# Fun Cup UK

## ! SERVICE NOTE !

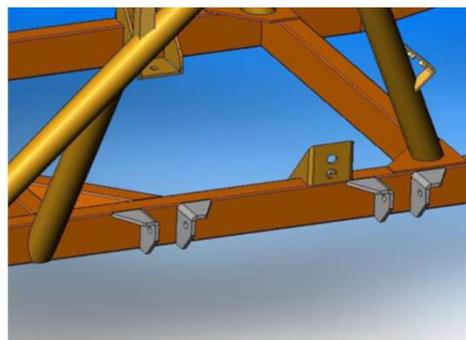
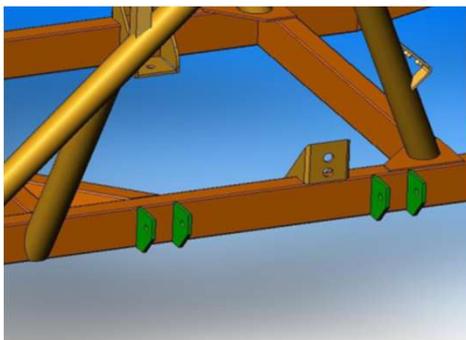
we have found that the welds on the rear wishbone tabs have cracked  
please check these welds

If cracks are found it is advised that you replace them with reinforced ones  
CH43G (left) and CH43D (right)

As a precaution we recommend you change these even if the weld looks good

If you change these yourself replace one by one and be sure to weld them in the correct place the  
correct spacing between the mounts is 44.3mm
